FRI GABE: SE 163.06 v REC		FESTIGKEIT:	VERTEILER:	DATUM:
HP-2-ASEO-ID-0083-02-0B			CI-121430	
FRI GABE: <i>W. W. 16.03.06</i>		CM:		
AUSGABE:		ZUL. ABW.:	OBERFL.:	MASSTAB: 1:2
		WERKSTOFF:		
		Herschel PFM CRYOSTAT HARNESS SVM INTERNAL CCH & SIH		
EADS Astrium GmbH		2547-121430-300-02-0B		
Friedrichshafen		ERS. F.:		
ERS. D.:		ERS. D.:

Drawing Change List
HP-2-ASED-ID-0083-02-0B: CRYOSTAT HARNESS SVM INTERNAL CCH and SIH

PANEL 5
SVM INSTRUMENT PANEL -Y (HIFI_1)
(SHOWN WITHOUT LOU WAVEGUIDE)

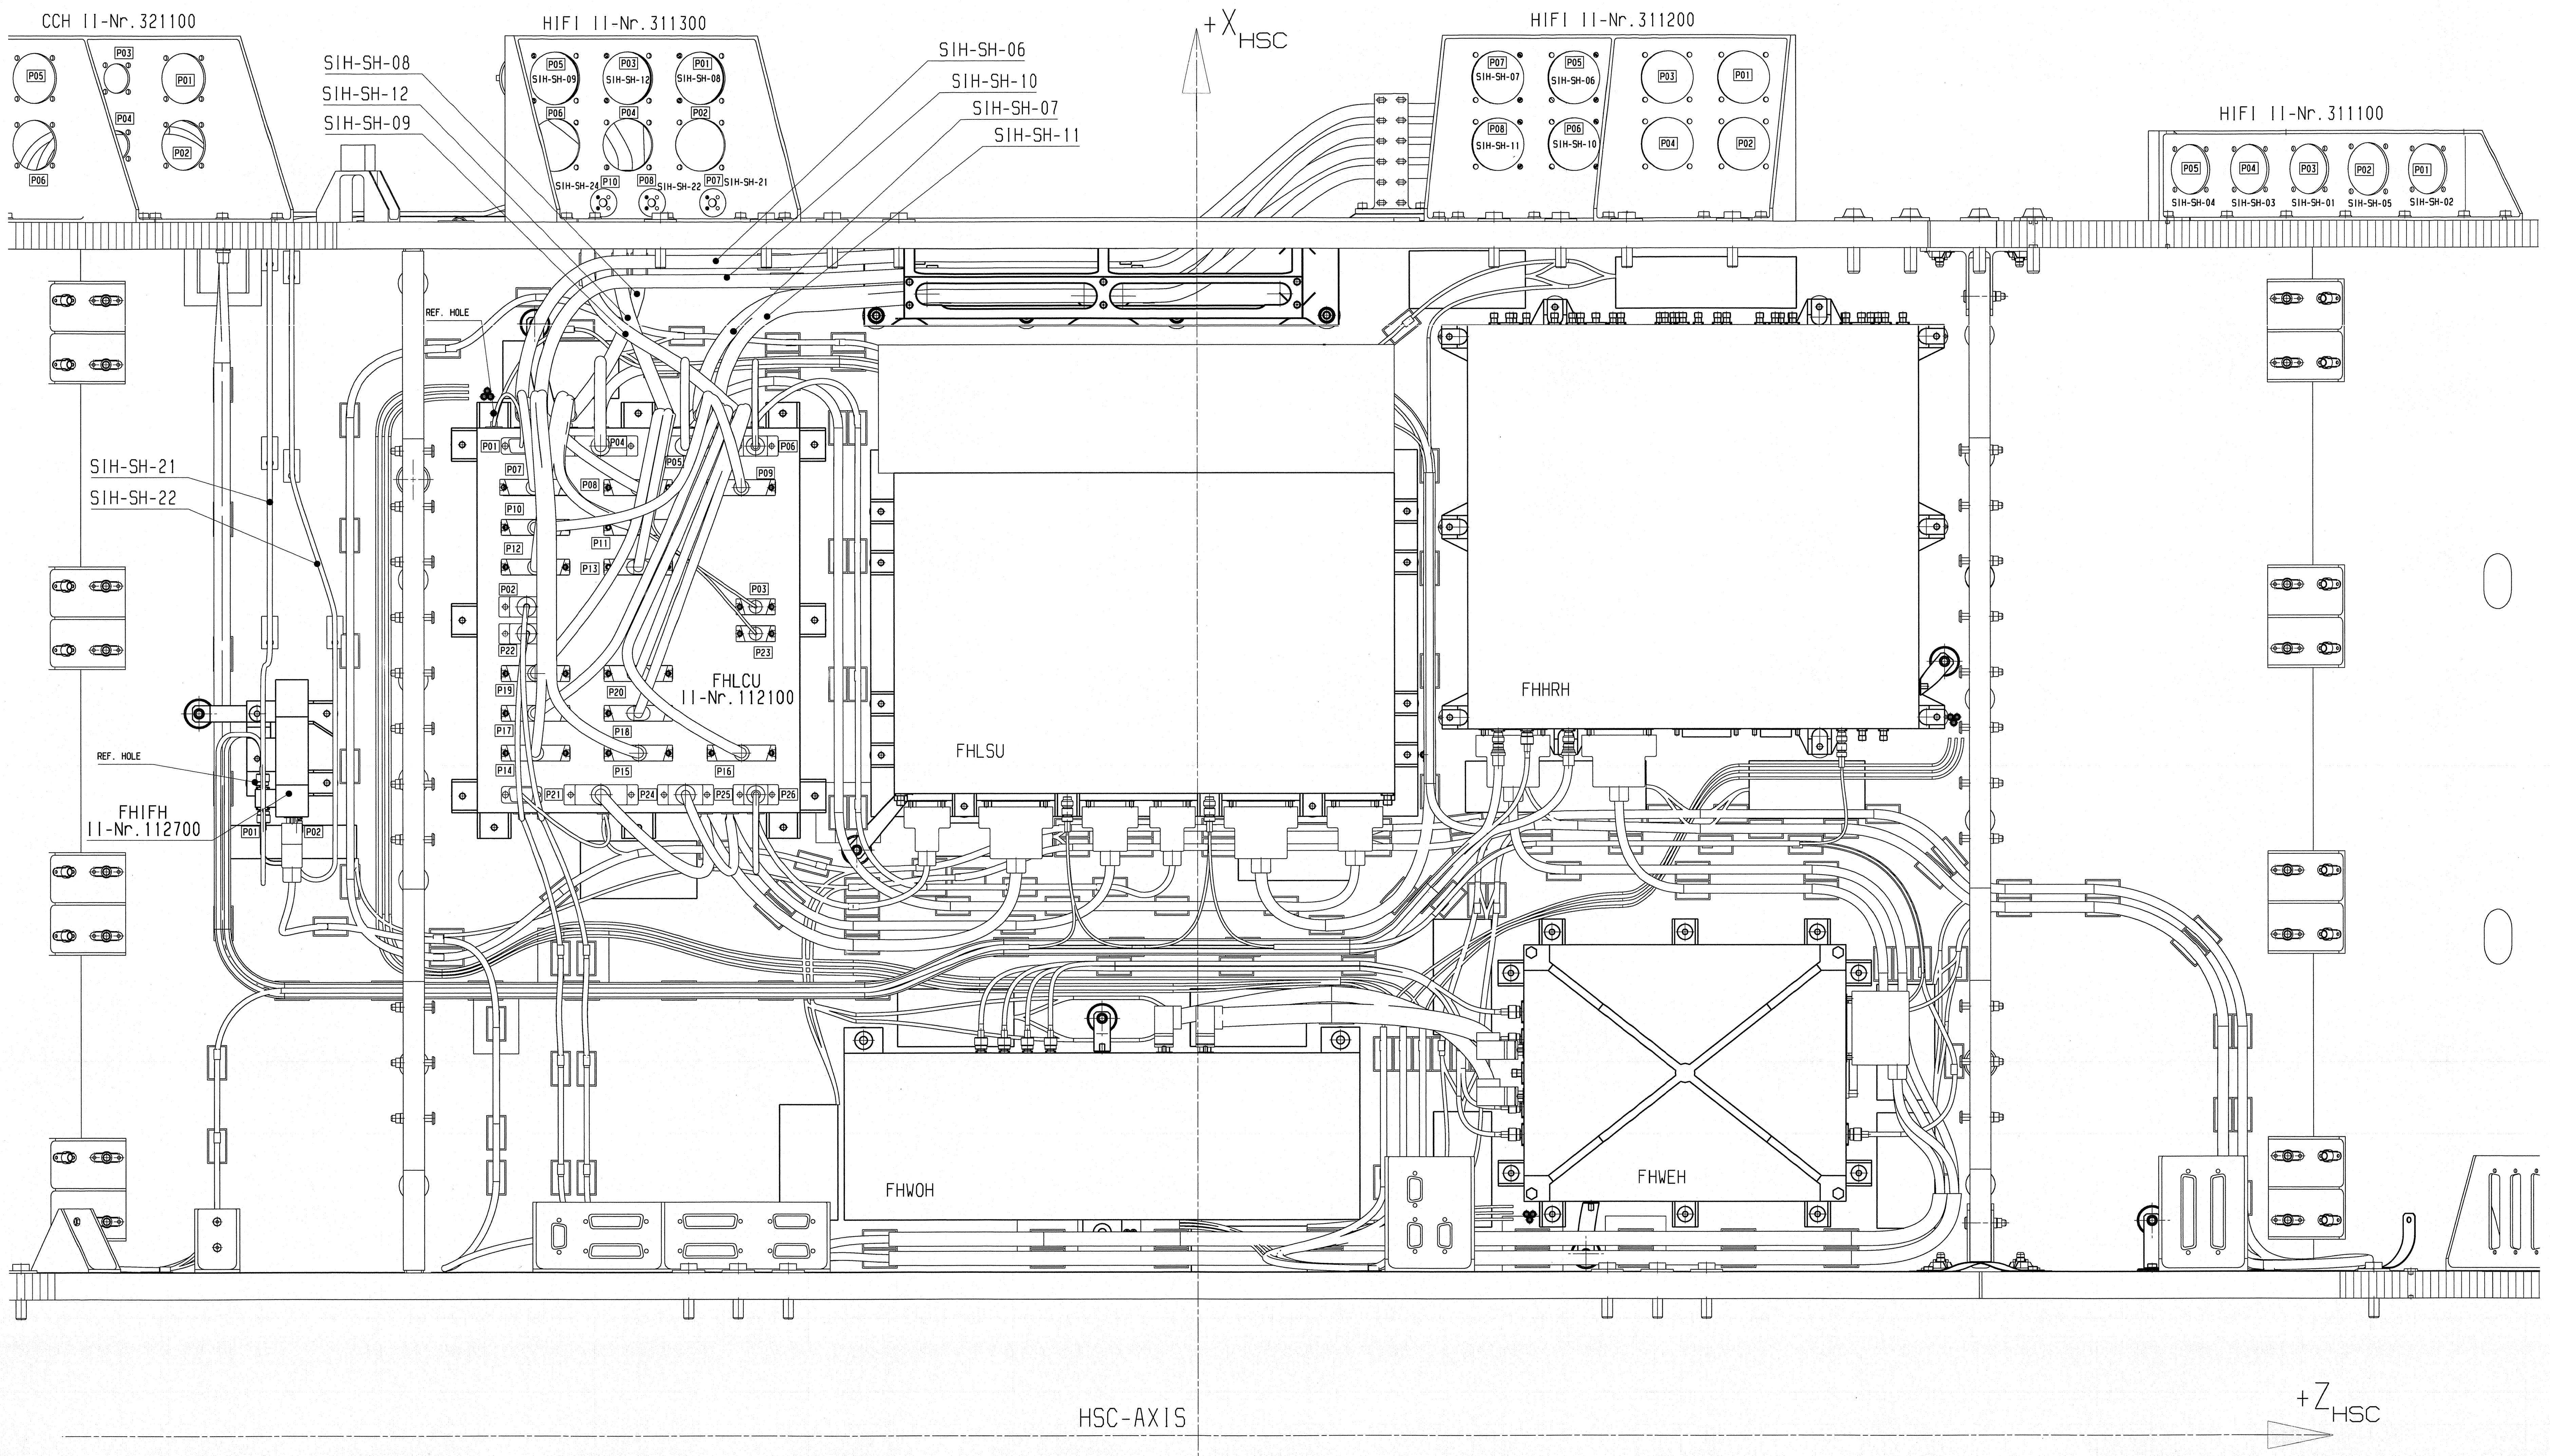
Related Drawing Section	Objective	Grid location	Actual Status Issue B	Previous Status Issue A
Sheet 02	Text changed	K7	Text changed : P05/SIH-SH-06 (HRN routing adapted)	P05

Sheet 02	Text changed	K7	Text changed : P06/SIH-SH-10 (HRN routing adapted)	P06/SIH-SH-08
Sheet 02	Text changed	K7	Text changed : P07/SIH-SH-07 (HRN routing adapted)	P07/SIH-SH-09

Sheet 02	Text changed	K7	Text changed : P08/SIH-SH-11 (HRN routing adapted)	P08/SIH-SH-12
Sheet 02	Text changed	K11	Text changed : P01/SIH-SH-08 (HRN routing adapted)	P01/SIH-SH-11

Sheet 02	Text changed	K12	Text changed : P03/SIH-SH-12 (HRN routing adapted)	P03/SIH-SH-07
Sheet 02	Text changed	K12	Text changed : P04	P04/SIH-SH-10
Sheet 02	Text changed	K12	Text changed : P05/SIH-SH-09 (HRN routing adapted)	P05/SIH-SH-06

Sheet 02	Text changed	K13	Text changed : SIH-SH-09, SIH-SH-12 and SIH-SH-08	SIH-SH-06, SIH-SH-07, SIH-SH-10 and SIH-SH-11
Sheet 02	Text changed	K10	Text changed : SIH-SH-06, SIH-SH-07, SIH-SH-10 and SIH-SH-11	SIH-SH-09, SIH-SH-12 and SIH-SH-08
